RE: Winmar Trail

Subject: **PARKS CONDITIONS FOR ACCEPTING TRAIL AT WINMAR
PROPERTY IN COLUMBIA SOUTH SHORE SLOUGH AREA**

RE: Alternatives and additional information regarding
LUR 93-00295 EN Appeal

WINMARE TRAIL ALIGNMENT
8/26/93

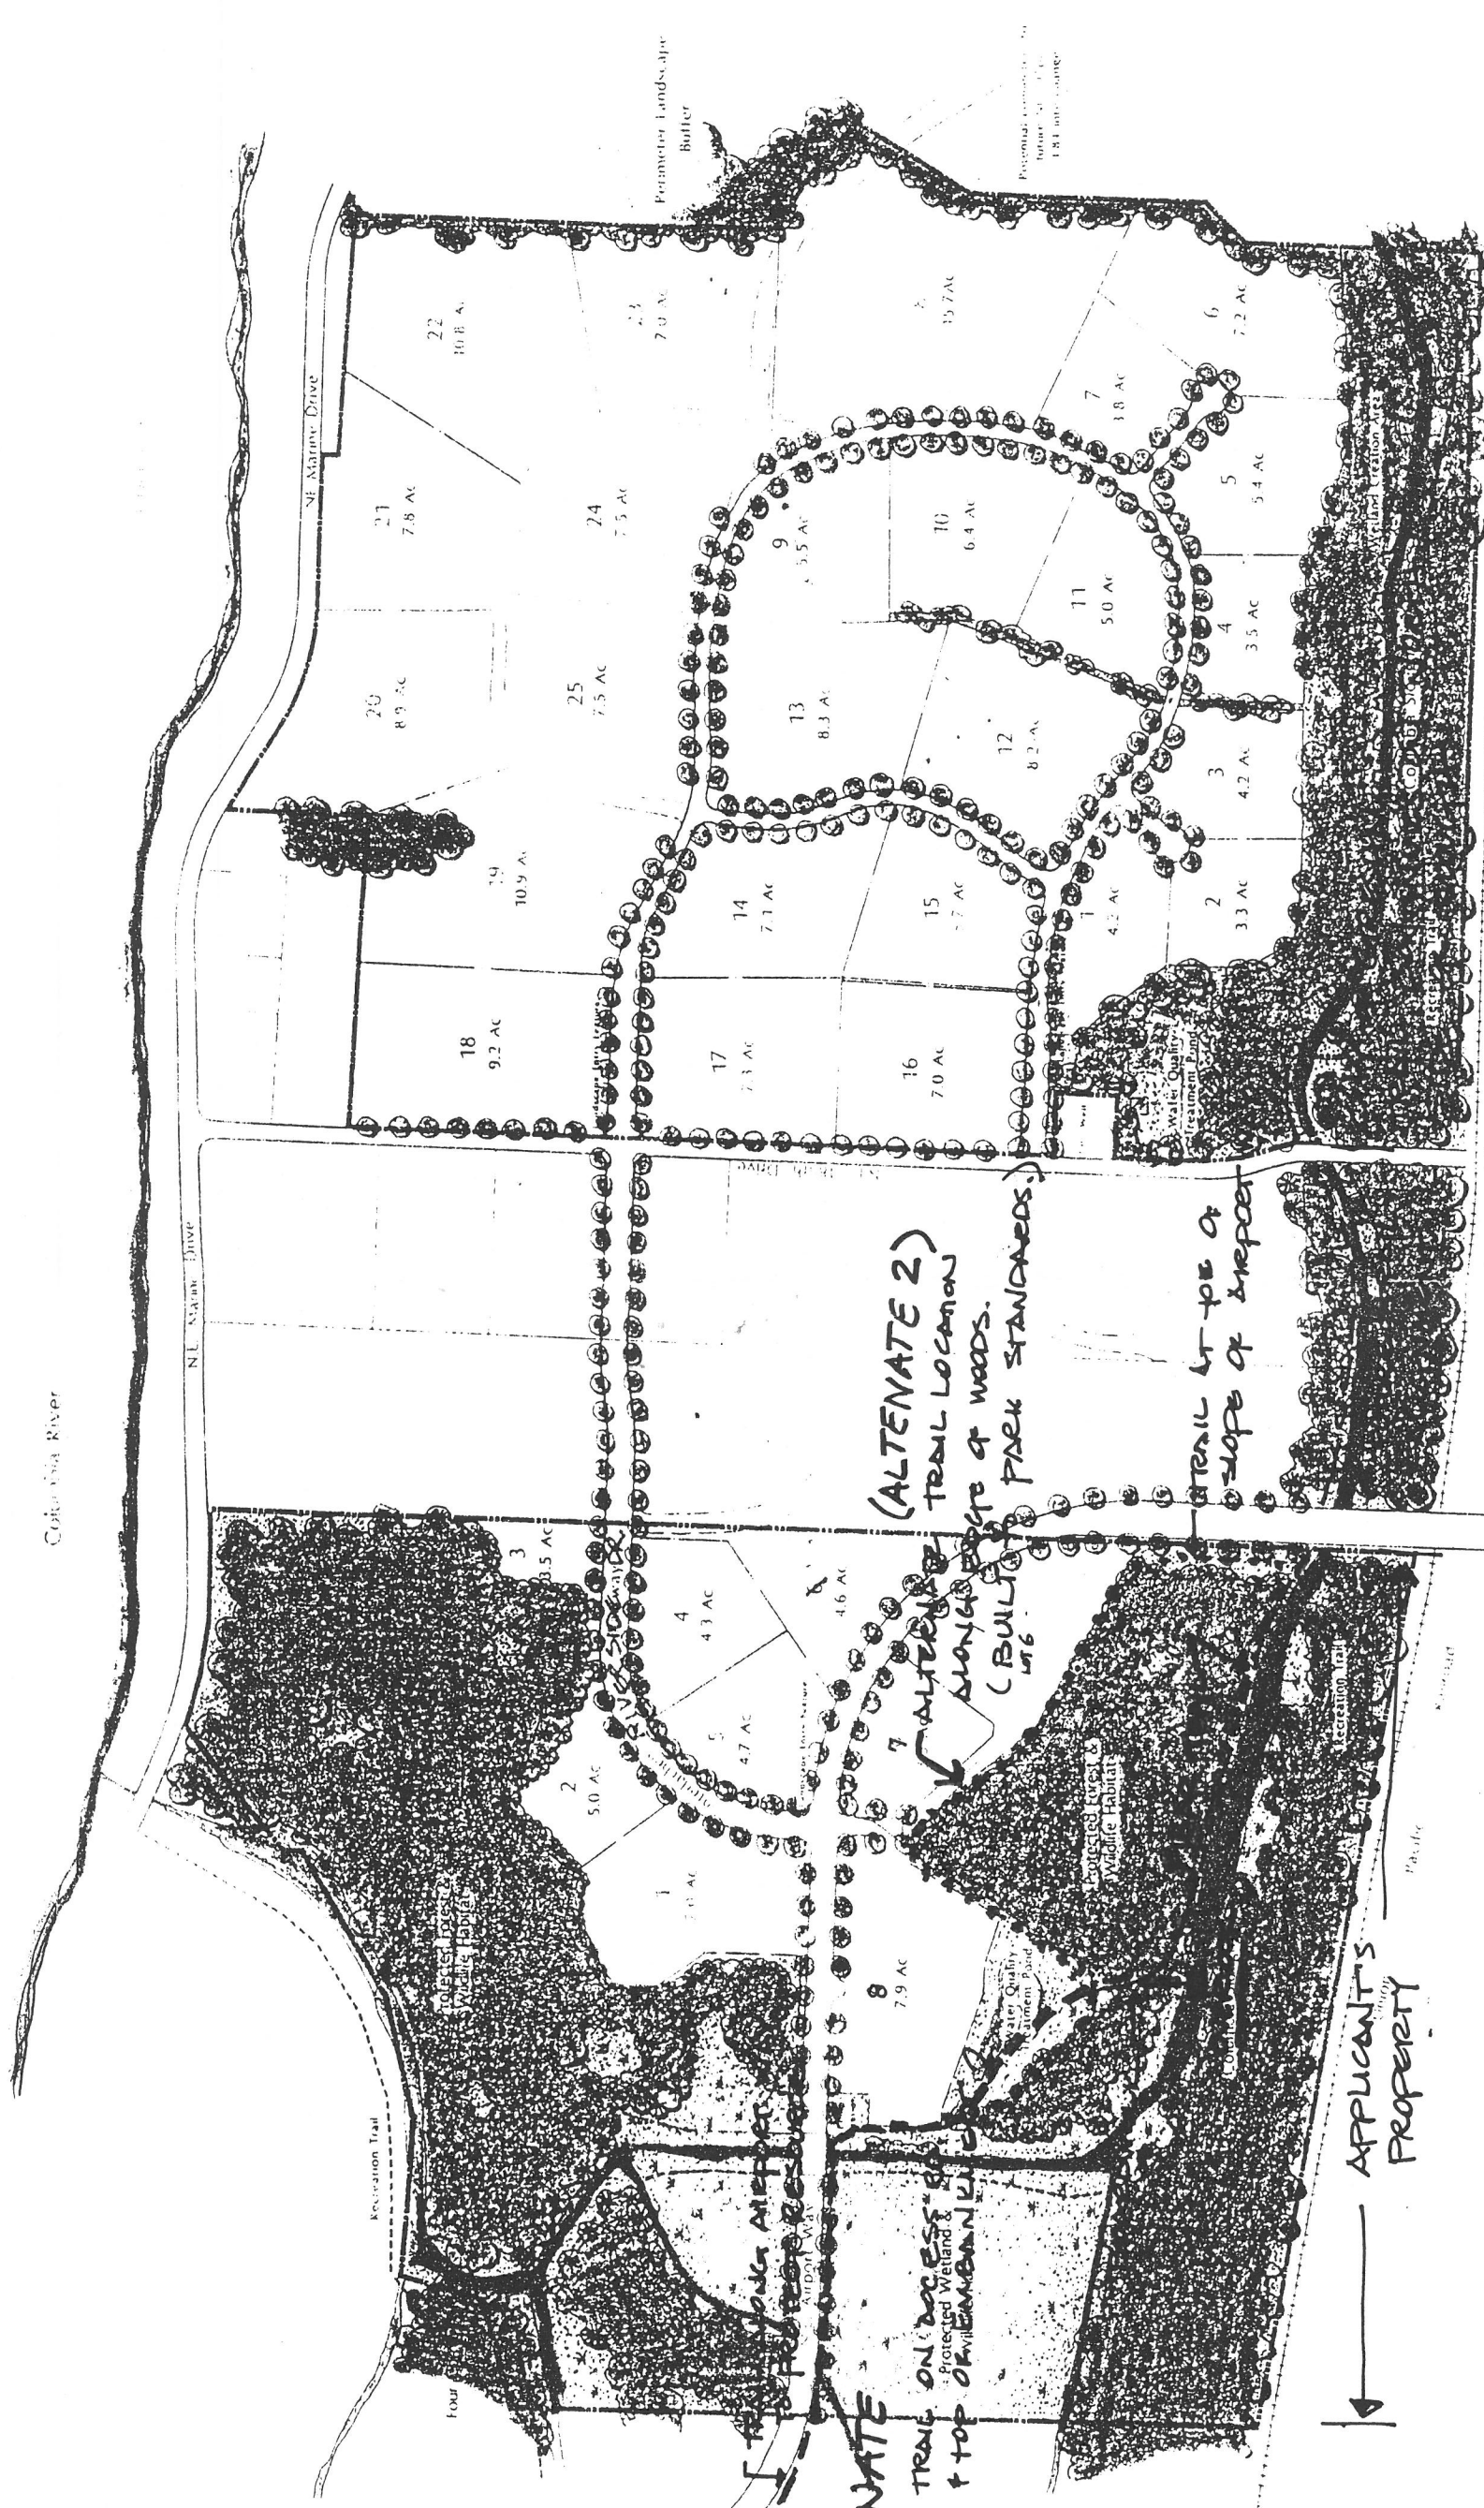
Alternative 1: Fibar Trail and Boardwalk Viewpoint

This alignment is similar to that proposed by the applicant however the trail would follow the access road used by the Bureau of Environmental Services, west of the water treatment facility. Then a soft surface trail must be constructed at the top of the treatment pond embankment. At this point the alignment will follow that of the applicants. A Fibar trail would be constructed at a width of six feet with a containment system. The Parks Bureau states they would take over the maintenance and liability responsibilities if it is found that the Fibar system can be maintained for a three year period.

Because of the maintenance and durability concerns, as well as concerns that the trail would not be usable during certain time of the year, a boardwalk and viewing area should also be developed. This boardwalk would extend from the pond embankment, south 250 feet, to the edge of the emergent wetlands. This walkway would allow the public to be close to this enhanced habitat area, while not directly impacting it.

Staff Comments: This alternative addresses the applicants concerns about future maintenance and liability responsibilities. It satisfies the neighborhood and trail advocates request that the trail extend into the resource area. It provides adequate assurance for the Parks Bureau that the alignment and surfaces can be maintained and that a viewing area is available when the trail is not passable during the rainy season.

Alternative 2: Recreational Trail Provided Along Edge of Development Sites

Retain the trail on the site. But, move it north of the enhancement area, at the edge of the water treatment facility and Lots 6 through 8. The trail would be located away from the slough, however; it would provide a separation from auto and truck traffic and would provide a natural setting on the southern side of the trail. If built to the City's soft surface standards, the Parks Bureau would take maintenance and liability responsibilities.

Staff Comments: Because the trail remains on the site, a Zoning Map amendment would not be necessary. This alignment would probably not satisfy the desires of the trail advocates or neighborhood. The Winmar Corporation does not favor this alternative. However, the Parks Bureau would have assurance that the trail could be maintained. Because the trail would be located outside of the enhancement area, there would be no resource impacts.

The Planning Bureau finds that a eight foot wide, 4-inch deep gravel base would be of greater impact and should not be built in this environmentally-sensitive area. Therefore, the Planning Bureau continues to find that Alternative 1 meets

the trail requirements and satisfies the concerns of the applicant and neighborhood groups.
